Administrative Action Group Housing Development

Case File / Name: **GH-7-11 / The Village at Town Center Apartments**

Nature of Case: A 288 Group Housing development comprised of 12 multi-family buildings on a 17.01 acre tract that is zoned Shopping Center - Conditional Use District. The gross acreage of this tract, counting right-of-way dedication associated with this tract, is to be 20.36 acres. After right of way dedication, the acreage will be 20.14 for a density of 14.3 units to the acre. This approval is amending the acreage noted for lot 1 in the approved subdivision; and these changes will be reviewed when the construction drawings for the subdivision are reviewed. As lot decrease, lot 3 will increase to be in excess of 1 acre.

OFFICIAL ACTION: Approval with conditions

GH-7-11 / The Village at Town Center Apartments – Preliminary Site Plan

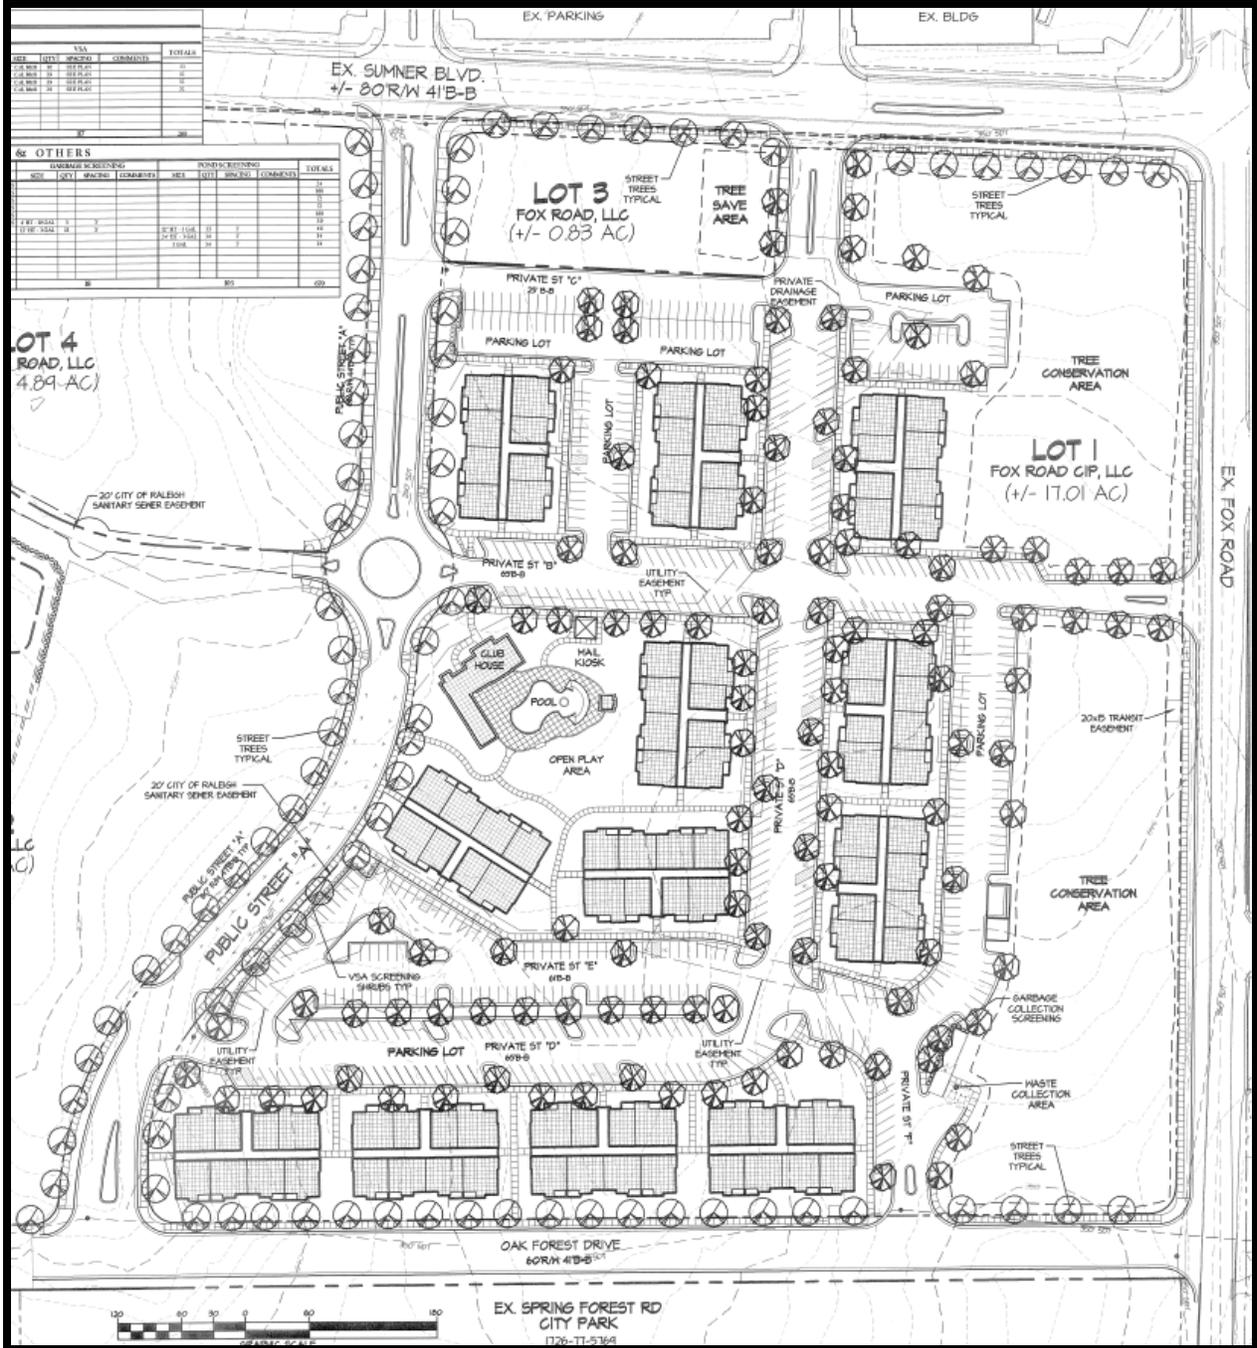
CONDITIONS OF APPROVAL:

- (1) That prior to grading permit issuance, the nitrogen offset payment must be made to a qualifying mitigation bank;
- (2) That all stormwater control measures and means of transporting stormwater runoff to and from any nitrogen and stormwater runoff control measures shall be shown on all plats for recording as private drainage easements and the plats shall contain the following note: "All private storm drainage easements & stormwater measures will be maintained by the homeowner association."

- (3) That prior to the issuance of a grading permit, the final tree conservation plan must be approved by the Forestry Specialist in the Inspections Department. The plan must show metes and bounds descriptions of all tree conservation areas, and tree protection fence around all tree conservation areas. Tree protection fence must be located in the field and inspected by the Inspections Department. A copy of the approved plan is placed on file in the Planning Department;

- (4) That construction plans with a phasing plan for public improvements, private streets and approach to stormwater be approved by the Public Works Department;
- (5) That all stormwater control measures and means of transporting stormwater runoff to and from any nitrogen and stormwater runoff control measures shall be shown on all plats for recording as private drainage easements and the plats shall contain the following note: "All private storm

- (6) That as Lot 1 is subject to Part 10, Chapter 9 of the City Code and will have a stormwater BMP (a wet pond) located on Lot 2 (of S-17-11), a stormwater covenant form is required to be recorded in accordance with lot recordation.

- (12) That a 15x20 foot transit easement located on Fox Road be approved by the Transit Planner in the Public Works Transportation Department, be shown on all maps for recording, and that a transit easement deed approved by the City Attorney is recorded with the local County Register of Deeds and a copy is returned to the Planning Department;
